**Addendum No. 1**  
**January 13, 2023**

Project: Baltic High School Addition  
Baltic, South Dakots  
Arch Project No. 2957

Architect: Architecture Incorporated

2.60

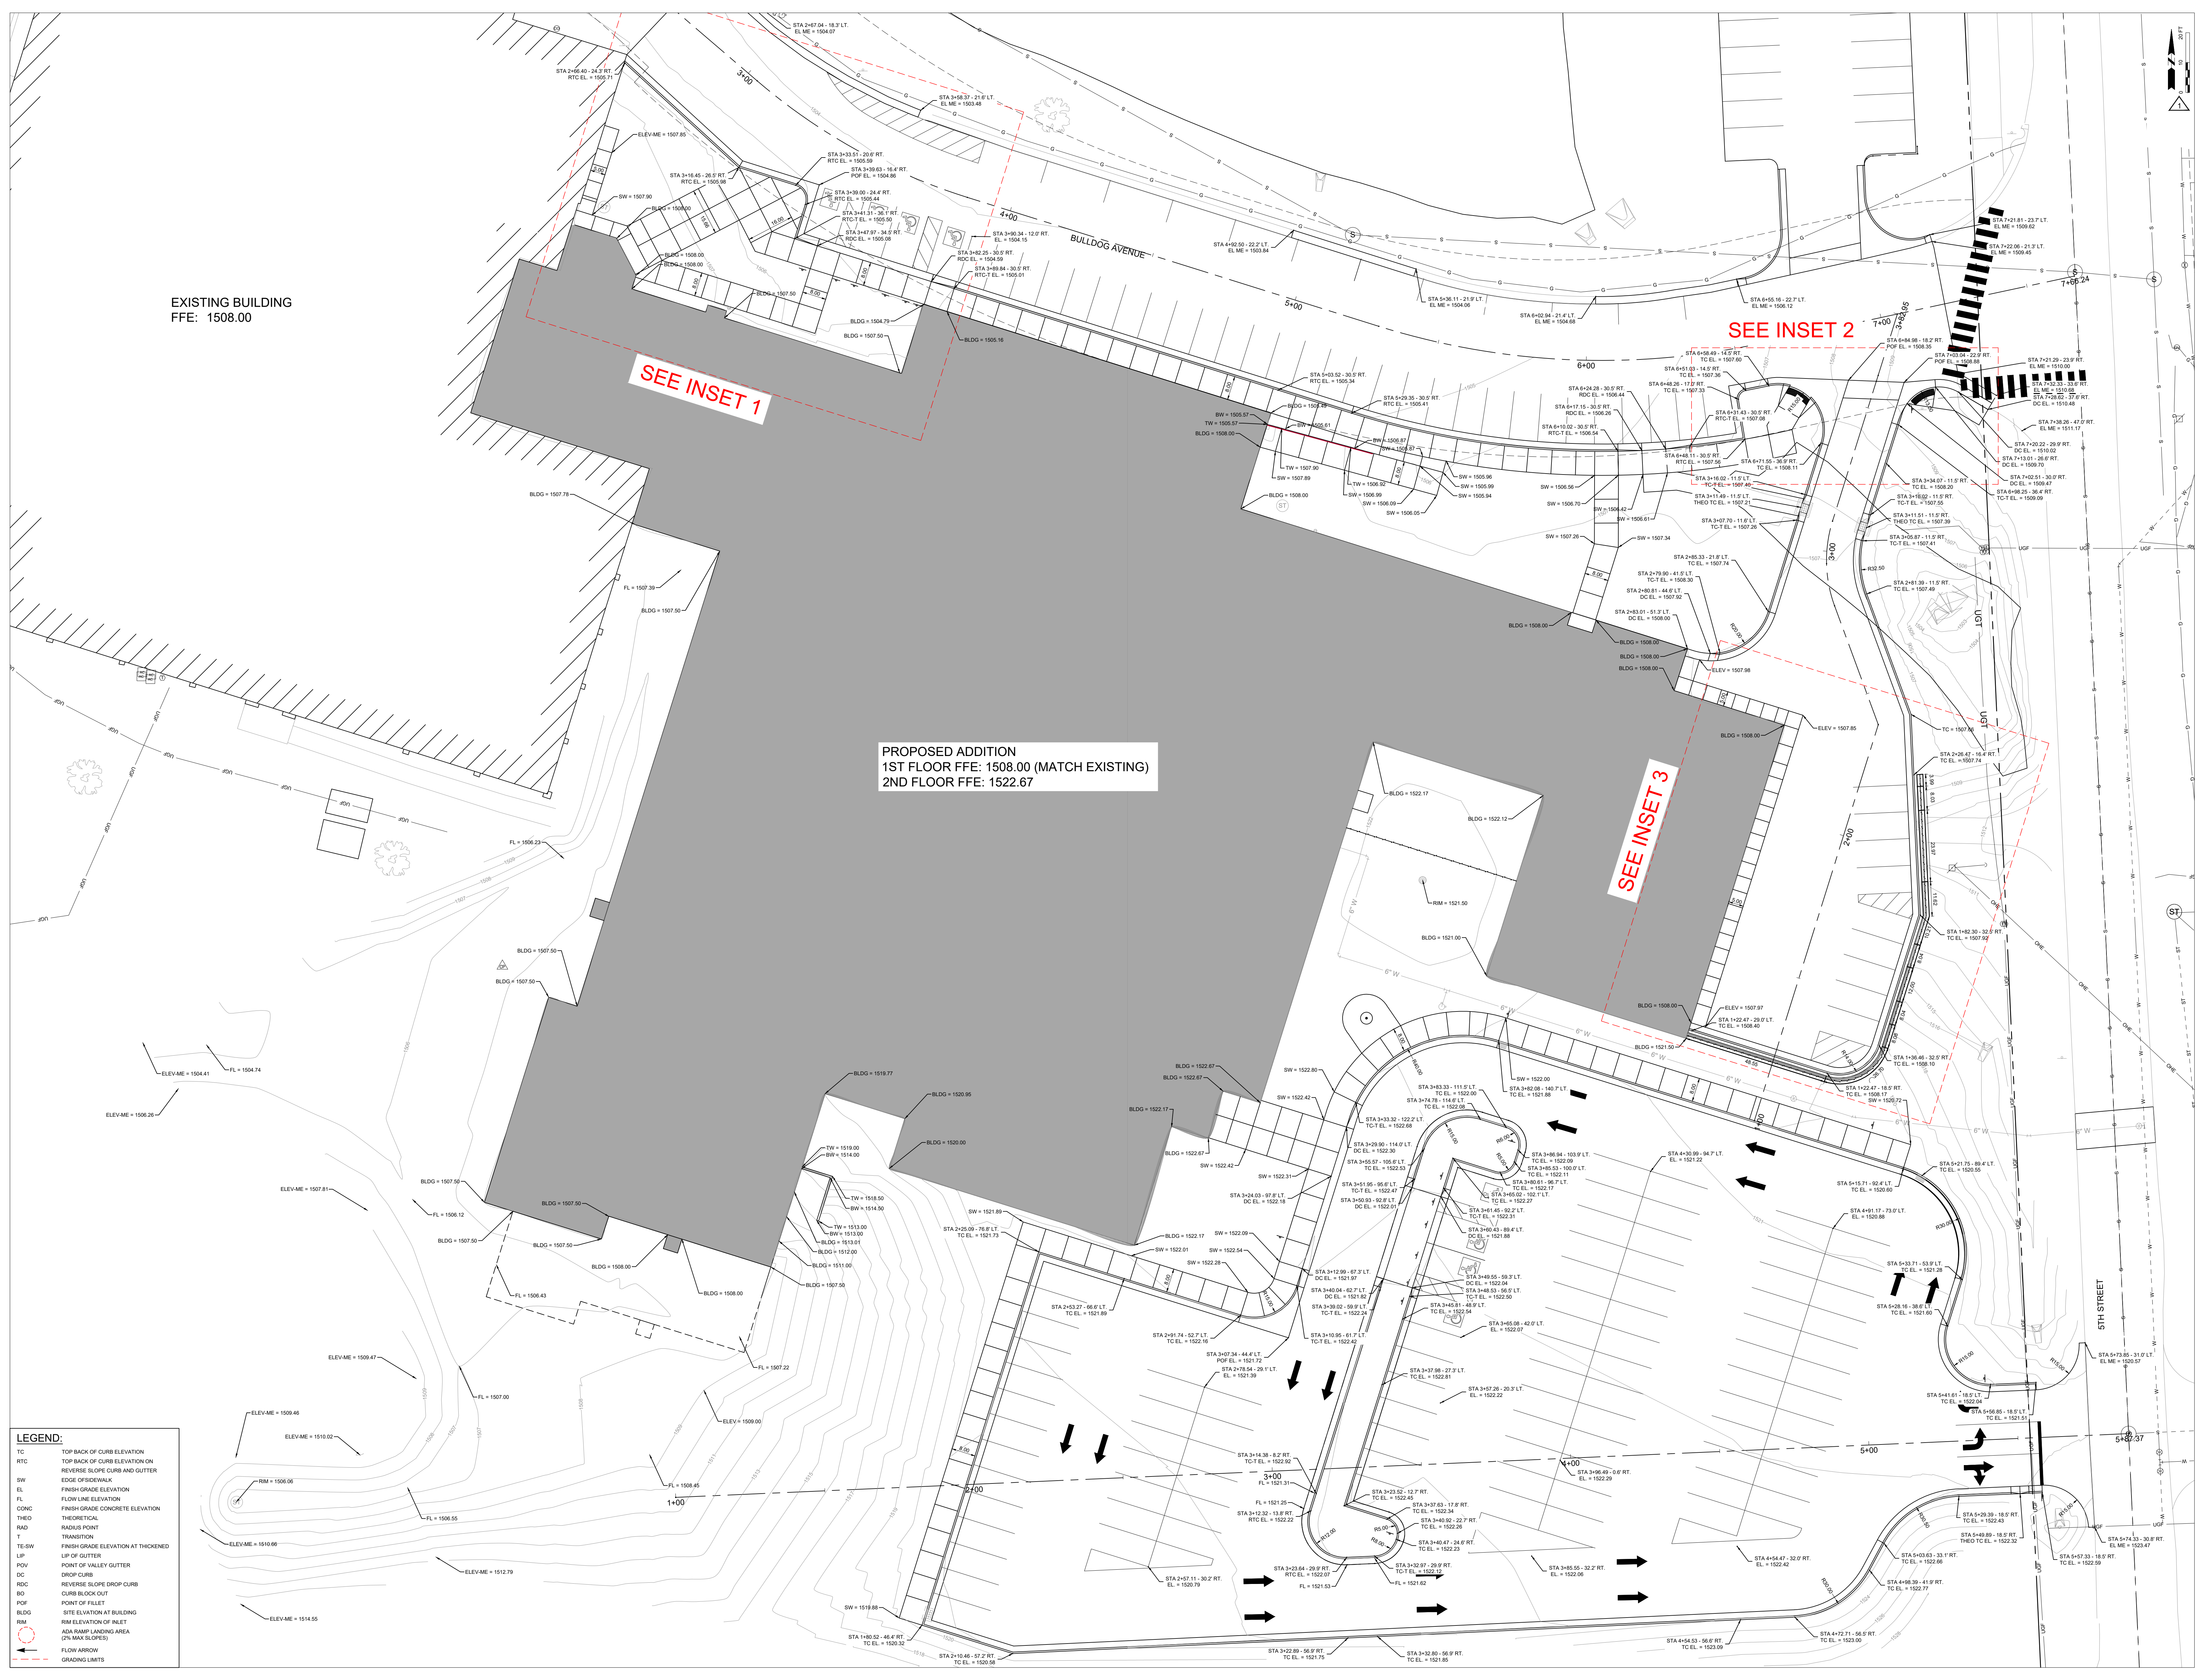
16) DRAWING 2.60 – GRADING AND SPOT ELEVATIONS PLAN

- a) The scale bar for this drawing Sheet has been updated / corrected; reference revised civil drawing Sheet 2.60 attached to the end of this addendum.

2.82

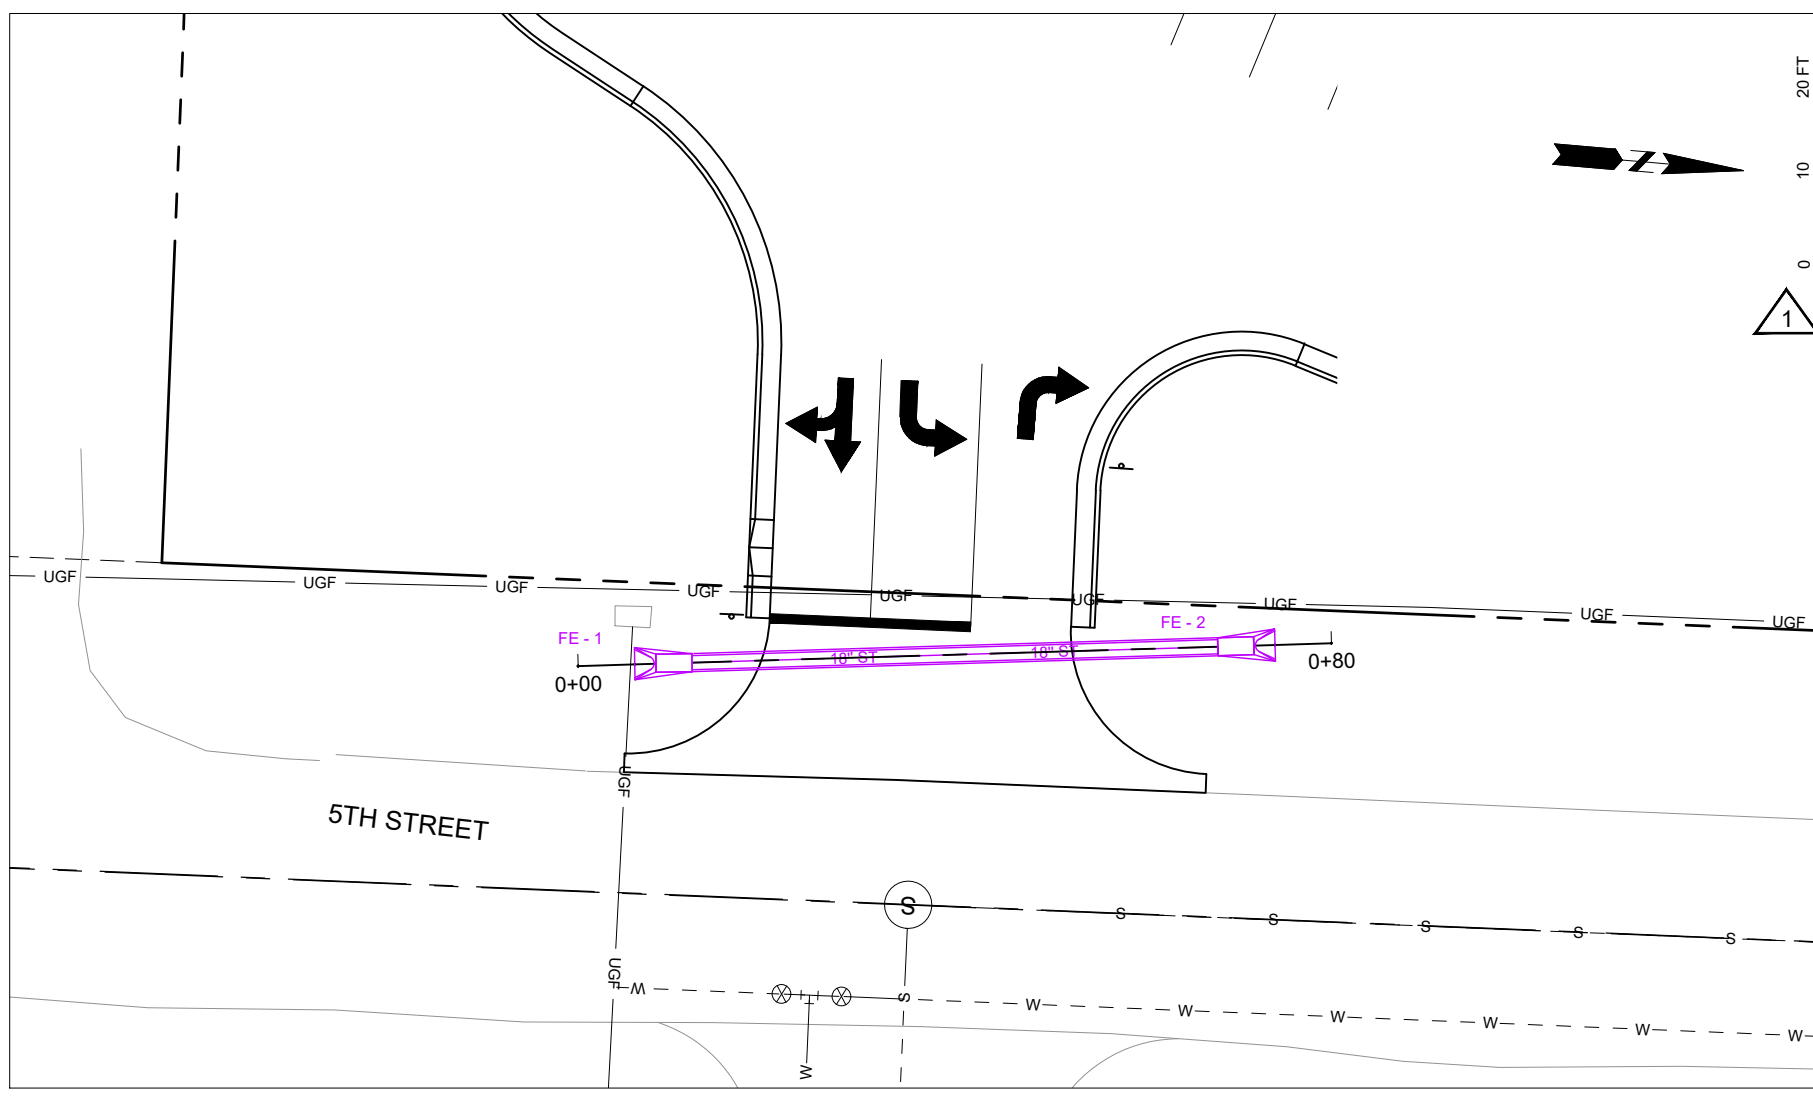
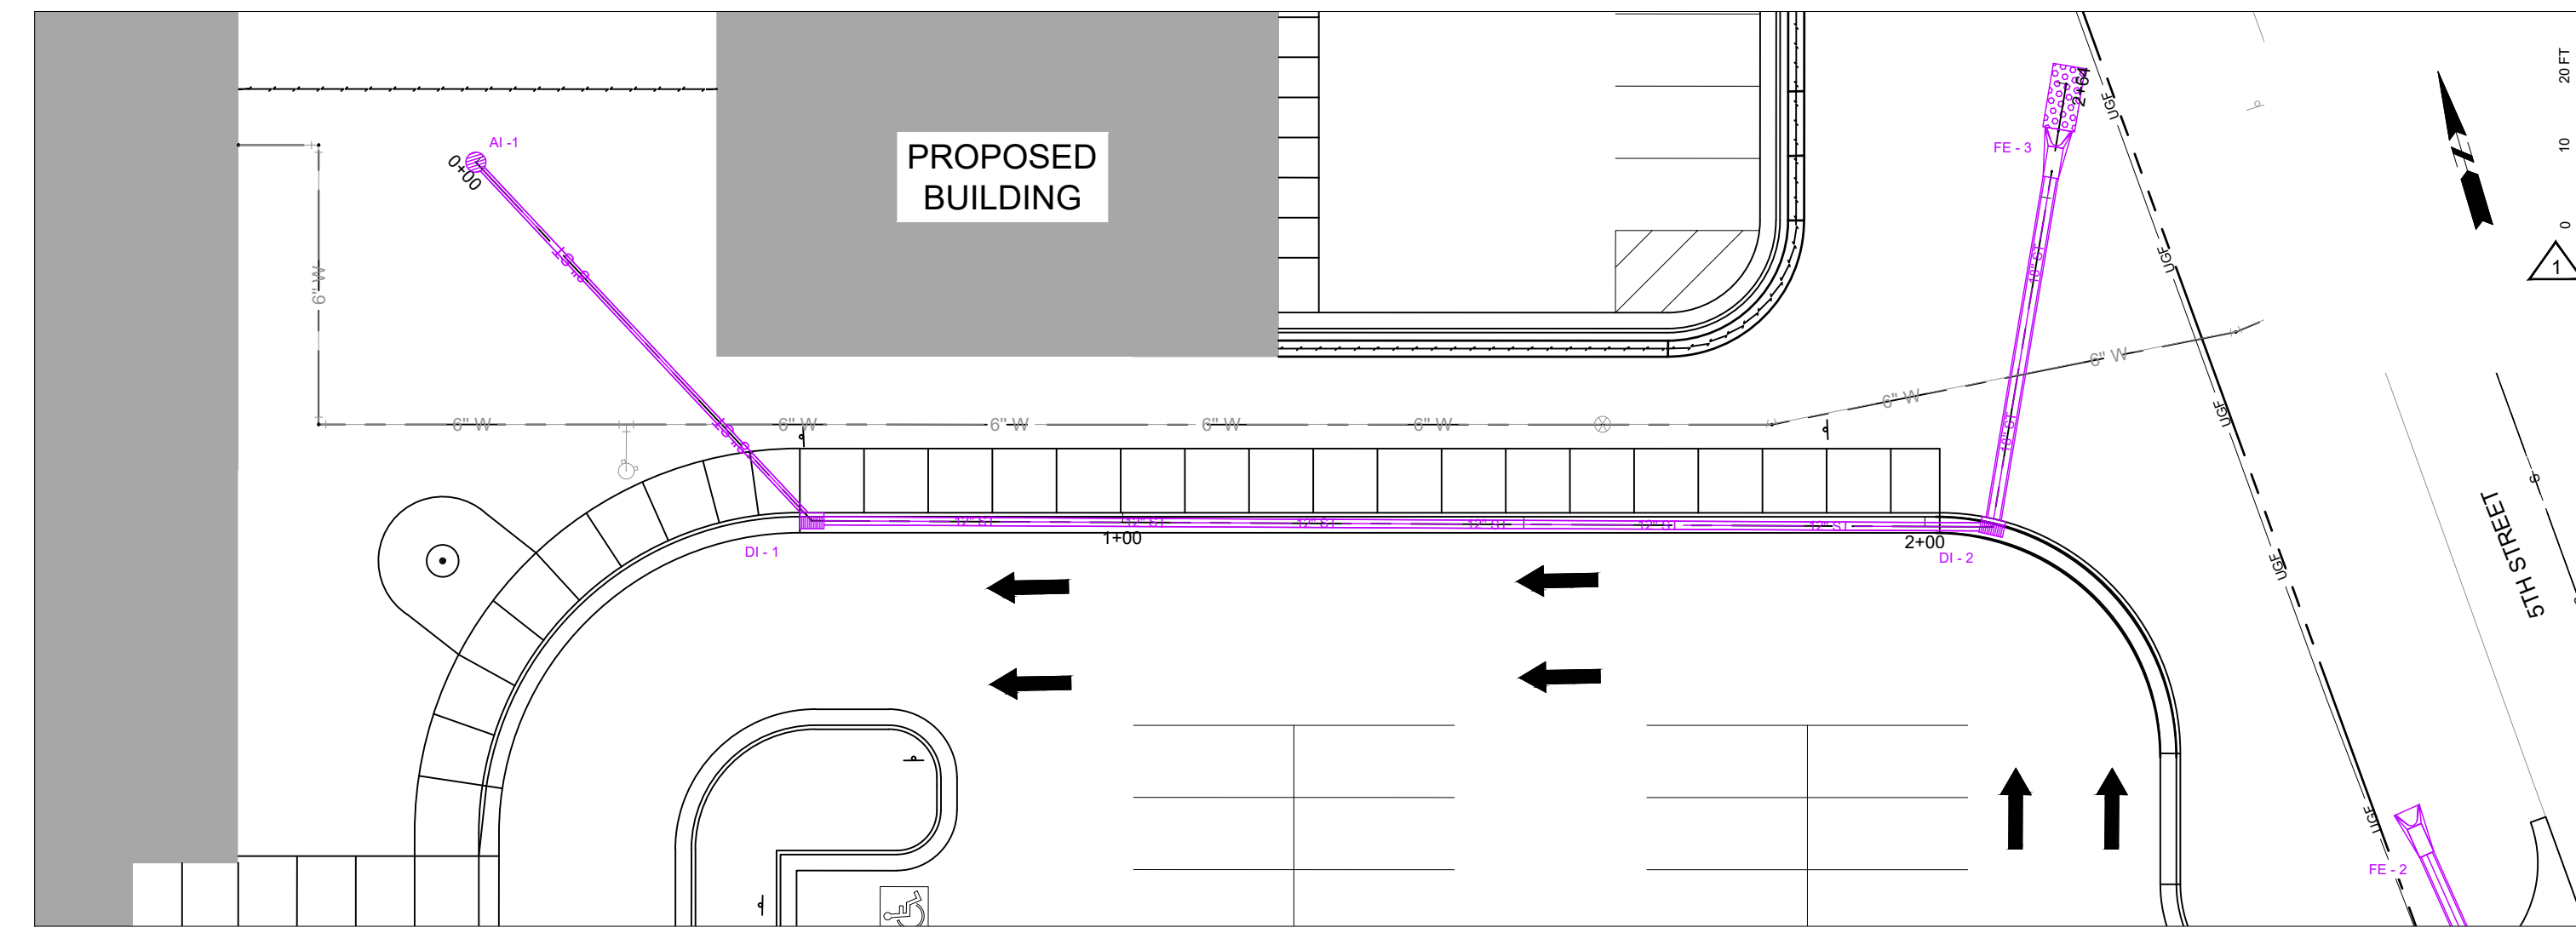
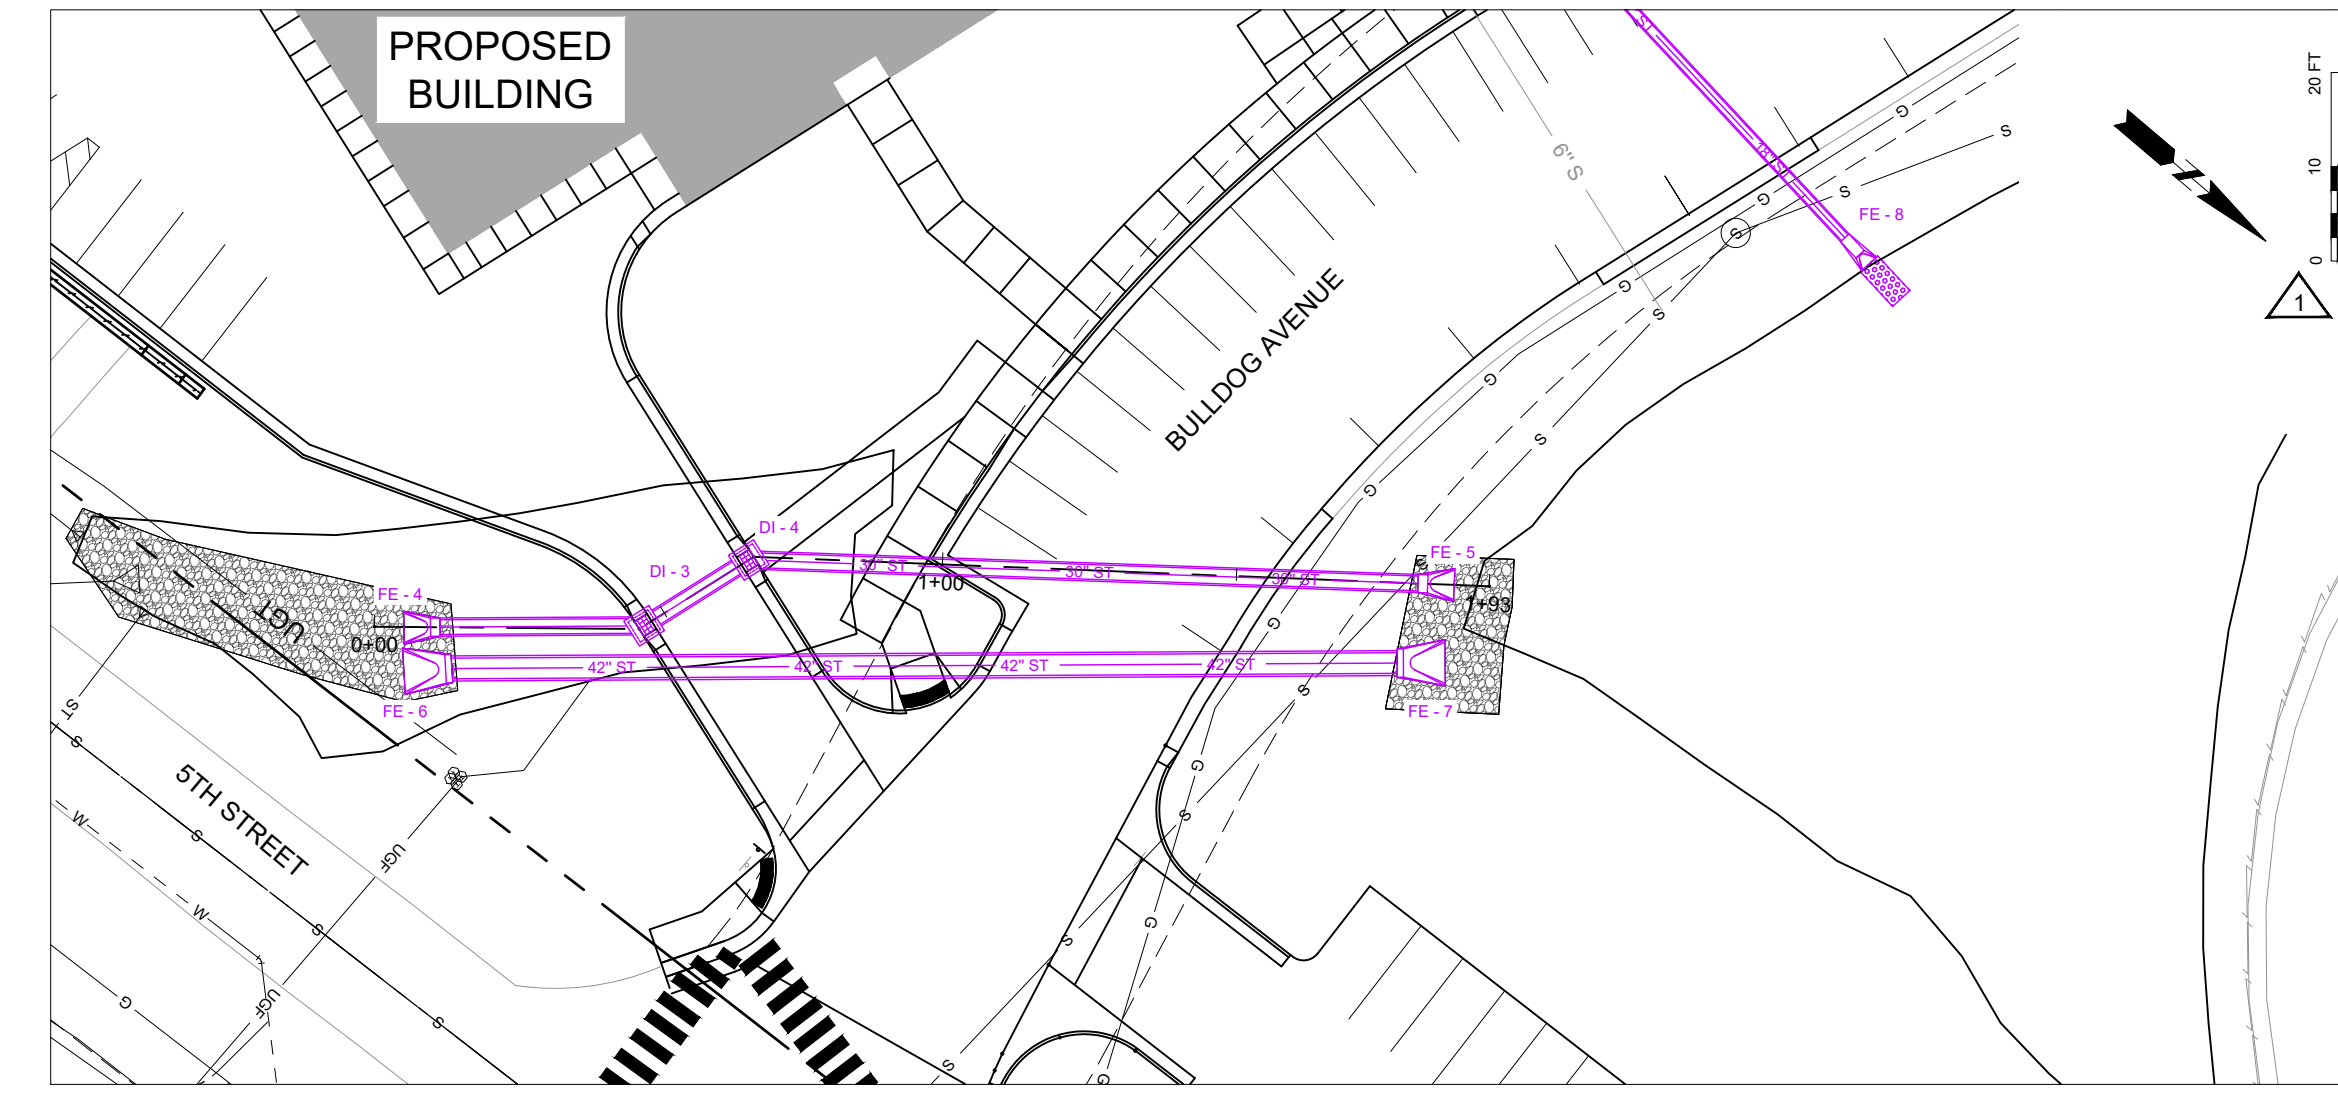
- 22) DRAWING 2.82 – STORM SEWER PLAN AND PROFILE
- a) The scale bar for this drawing Sheet has been updated / corrected; reference revised civil drawing Sheet 2.82 attached to the end of this addendum.
